Tuesday, June 22, 2021
Medway Planning and Economic Development Board
REGULAR MEETING
155 Village Street
Medway, MA 02053

PUBLIC HEARING CONTINUATION -WINGATE FARM SUBDIVISION
MODIFICATION:

PUBLIC HEARING CONTINUATION - 23 JAYAR ROAD - GOOD FEELS MARIJUANA SPECIAL PERMIT MODIFICATION:

PUBLIC HEARING CONTINUATION MEDWAY PLACE SHOPPING PLAZA SITE PLAN 98,108, AND 114 MAIN STREET:

FIGURE 1. Facility layout in computer model (see project mechanical drawings for source locations)

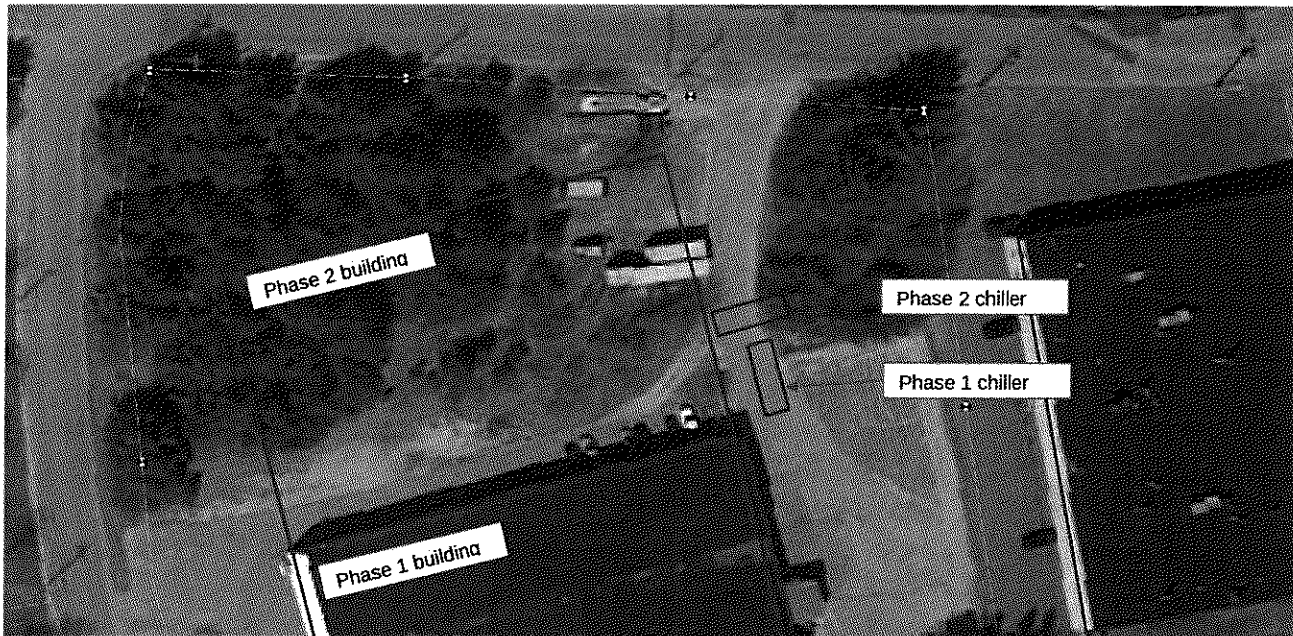
R09 looks to be about 10 Green Valley Rd; there are many closer residences.
